MIL-S-19500/372A(ER)
AMENDMENT 6
2 September 1991
SUPERSEDING
AMENDMENT 5
22 June 1977

MILITARY SPECIFICATION

SEMICONDUCTOR DEVICE, THYRISTOR (CONTROLLED RECTIFIER), SILICON
TYPES 2N4199 THROUGH 2N4206

FIGURE 7. Peak forward gate voltage, v_{GK} , test circuit."

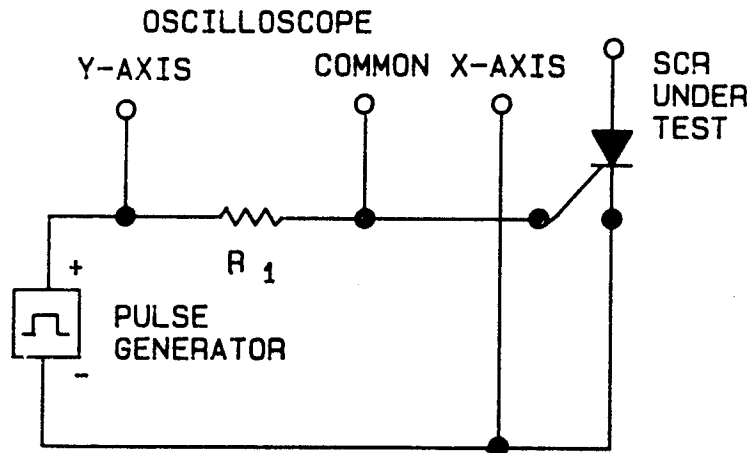
Figure 7, delete and substitute the following:

CIRCUIT ELEMENTS
AND CONDITIONS:
 $R_1 = 2$ ohms, 50 W, $\pm 1\%$
 $t_p = 10$ μ s; prr = 100 pps
 $t_p = 1$ s, minimum

PROCEDURE

- (1) Apply sufficient generator signal such that 10 volts is applied between gate to cathode (V_{GK}). (Gate current (i_g) shall be a minimum value of 2 amperes during this time.)
- (2) Following step (1), apply sufficient generator voltage such that 5 amperes of gate current (i_g) flows. (Gate to cathode voltage (V_{GK}) developed during this interval shall be 4 volts minimum.)

Note: If, during the test, either of the minimum test conditions of a. 2 amperes as in (1), or b. 4 volts as in (2), cannot be obtained during the test as specified, increase the generator voltage until the minimum condition above is met.
